Port of Savannah's Channel

The following report was prepared by Asaf Ashar¹, a port and shipping consultant for the Southern Environmental Law Center (**SELC**). SELC asked Ashar to critically review the US Army Corps of Engineers' (**Corps**) studies on the Savannah Harbor Expansion Project (**SHEP**). The SHEP involves deepening and widening the access channel to the Port of Savannah.

Figure 31: Unit Cost by Sailing Draft

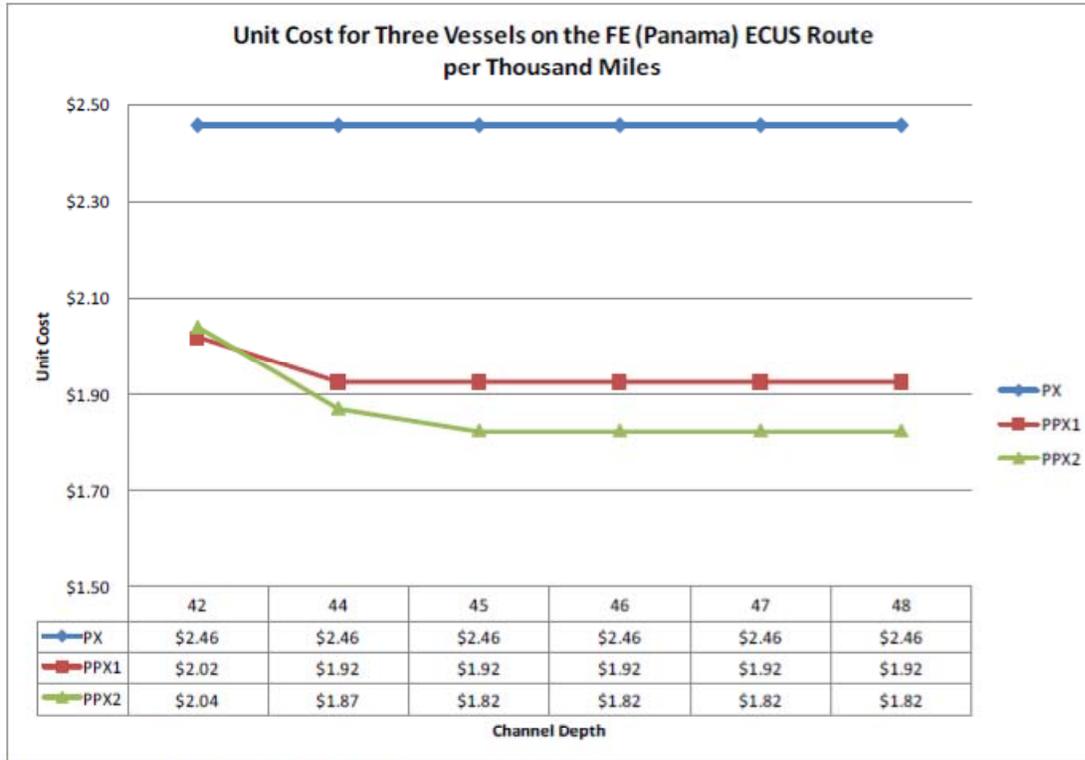
The following [Figure 31](#) (EconApp, p. 67) illustrates the unit costs of PX, PPX1 and PPX2 in different channel depths. As seen in this figure, the cost of PX at a channel depth of 42 ft is \$2.46, while that of PPX1 only \$2.02. It is interesting to note in this figure that the PPX2’s unit cost chart is flat once the channel depth reaches 45-ft, suggesting that the vessel at this point has fully utilized its slot capacity (“cubed out”) and therefore cannot take advantage of the additional channel depth. Another interesting (or, perhaps, strange) observation is that the PPX2’s cost is only \$0.10 or about 5% (1.82/1.92) lower than that of the PPX1, while its capacity is about 40% (8,700/6,200) higher.

Figure 31: Unit Cost by Sailing Draft

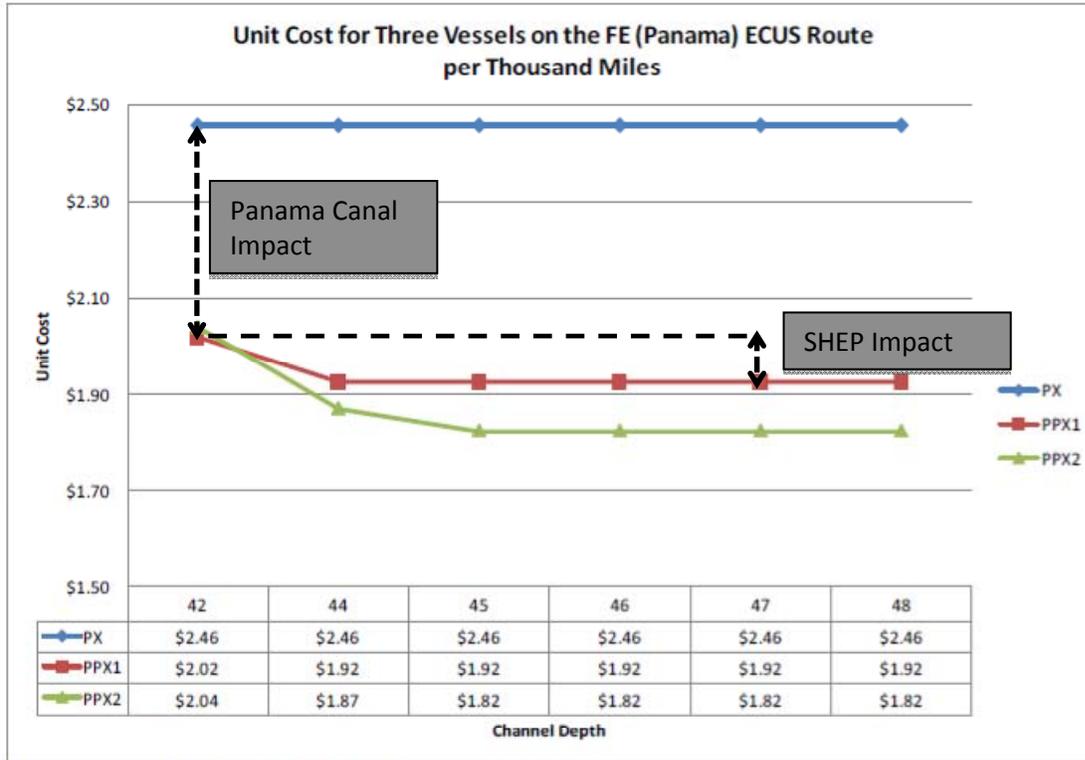
To re-capitulate, the total unit savings of \$0.54 (2.46 – 1.92) in the case of replacing PX by PPX1 should be separated into:

- **Ship Replacement Savings due to Panama Canal Expansion –**
PX at 42-ft to PX1 at 42-ft = $\$2.46 - \$2.02 = \$0.44$
- **Channel Deepening Savings due to SHEP–**
PX1 at 42-ft to PX1 at 47-ft = $\$2.02 - \$1.92 = \$0.10$

Accordingly, the reduction in benefits attributed to the channel deepening in this case is substantial, from \$0.54 to \$0.10. A modified Figure 3 illustrates the 2-stage process of reduction in unit cost.
